Full Planning Approval Consultation

Application Number: 261866

Site Address: Warren Crest Farm, Wick Hill Lane, Finchampstead, Wokingham, RG40 3PY

Proposal: Full application for the proposed improvement of the existing highway access.

The applicant has included a Stage 2 Road Safety Audit (RSA) (dated 12 March 2026) and S.278 Highway Works Engineering Layout (8250668/4300 Rev A6).

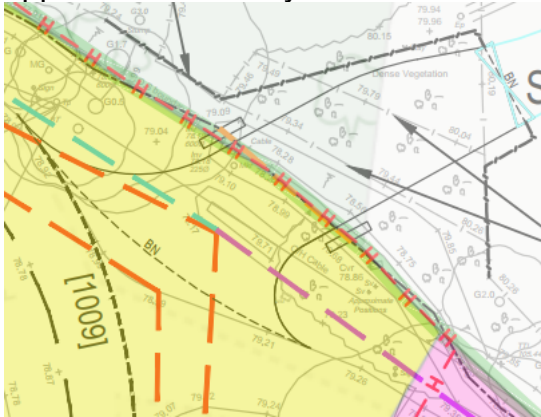
While the Highways Authority welcomes additional details to be submitted, these documents have to be reviewed by Highways Agreements team, and separate application for technical acceptance is required beyond the planning application process. This will be secured via planning condition and informative.

According to the Appendix A of TSM Chapter 4, the siting distance of warning signs for the observed 85th percentile speeds shall be 45-110m, so that the siting distance is acceptable in principle. However, further comments have been provided regarding the position of signs, which is expanded in the next section.

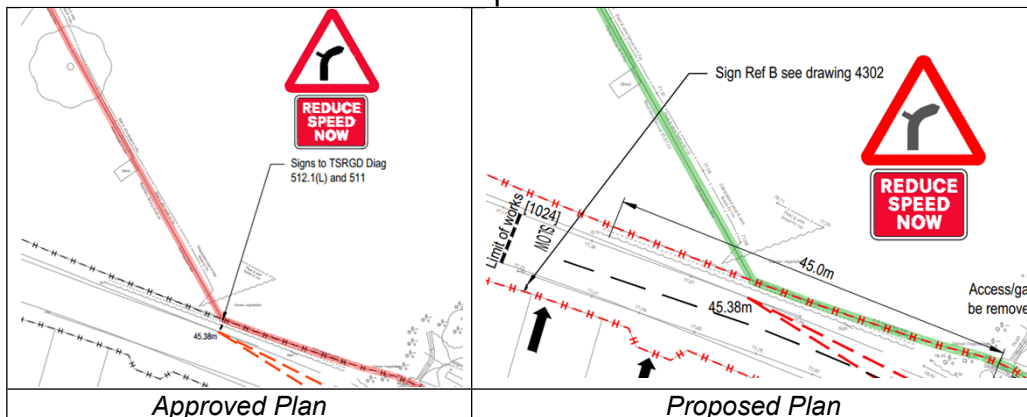
- Two rectangular boxes have been proposed on both sides of the access in the swept path analysis and engineering layout. While they are set back from the edge of carriageway and have no negative impact to visibility splays, it is unclear if they are physical structures to be installed above the ground.

- Half of the proposed rectangular boxes will be sited within the adopted highway (in yellow). If they are to be installed above the ground, the applicant shall clarify the nature and intention of the boxes:

- The proposed locations of the signs in the engineering layout are significantly different with the approved drawings.
 - Chapter 4 of TSM states that warning signs should normally be placed on the left-hand side of the road (as approved in 8240747/6101 Rev. B), but the proposed warning sign below has been placed on the right-hand side. The applicant has not justified for the proposed revision in this proposal, so it is unclear if this has been misplaced.
